UNITED STATES PATENT AND TRADEMARK OFFICE

APPLICATION NO.	FILING DATE	FIRST NAMED INVENTOR	ATTORNEY DOCKET NO.	CONFIRMATION NO.
10/581,325	06/01/2006	Dieter Hagist	502901-348PUS	3578

Office Action Summary	Application No. 10/581,325	Applicant(s) HAGIST ET AL.	
	Examiner AMENE S. BAYOU	Art Unit 3746

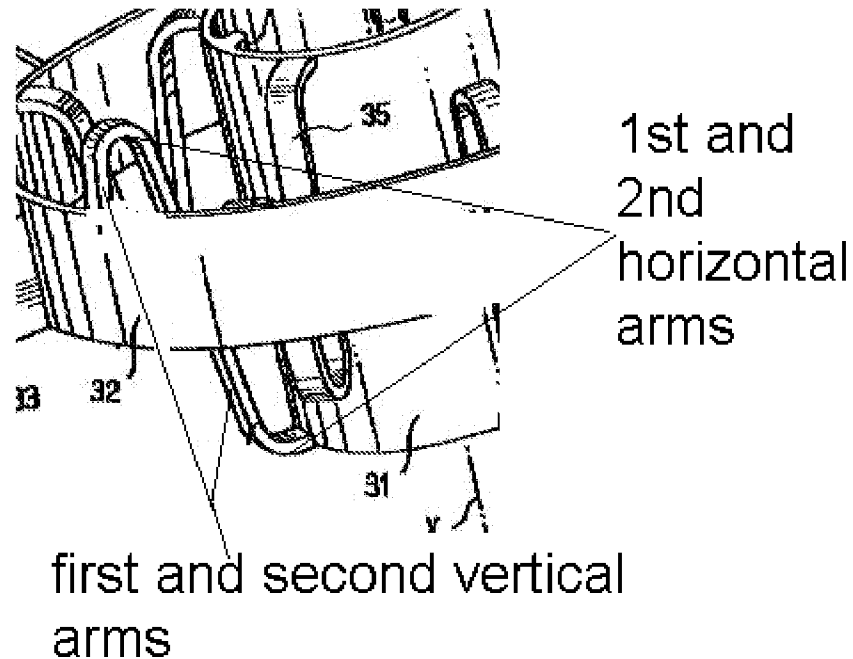
Firtion et al disclose a device for retaining a fuel pump in a fuel container of a motor vehicle **(see figure 2 and 3)** , comprising a **pump holder (30) including: first retaining means (42,43,44)** for supporting the pump holder on a baffle pot; **second retaining means (57 integral with 31)** for supporting the **fuel pump (15)** , and a **damping device (32,34,35)** connecting the first and second retaining means, the **damping device (34,35)** comprising a **first annular element (32)** and a plurality of arms (all the vertical and horizontal arms of elements 34 and 35) , wherein the arms are subjected to a torsional or a bending load (inherently) when the fuel pump in the **second retaining means (57 integral with 31)** moves relative to the **first retaining means (42,43,44)**, thereby effecting an elastic retention of the fuel pump, wherein the arms include; at least one first vertical arm **(34 ,35 both have vertical arm)** connected to the **first annular element (32)** ,the at least one first vertical arm extending substantially in a vertical direction and further connected to the **first retaining means (42,43,44 as unit is connected to annular element 32 which in turn is connected to the vertical arm of 34 and 35)**;first and second horizontal arms **(both 34 and 35 have horizontal arms)** spaced apart in the vertical direction **(clearly shown in figure 3A)** ,each of the first and second horizontal arms comprising annular elements (the horizontal arms are interconnected in annular fashion via ring 32), only the first horizontal arm of the first and second horizontal arms being connected to the at least one first vertical arm ,the second horizontal arm of the first and second horizontal arms being connected to the second

retaining means ;and a second vertical arm connecting the first and second horizontal arms (see annotated drawing below) .

Firtion et al disclose a device for retaining a fuel pump in a fuel container of a motor vehicle (see figure 2 and 3),wherein the **second retaining means (57 integral with 31)** includes a section of pipe for receiving the fuel pump, the first and second horizontal arms surrounding a circumferential surface of the section of pipe.
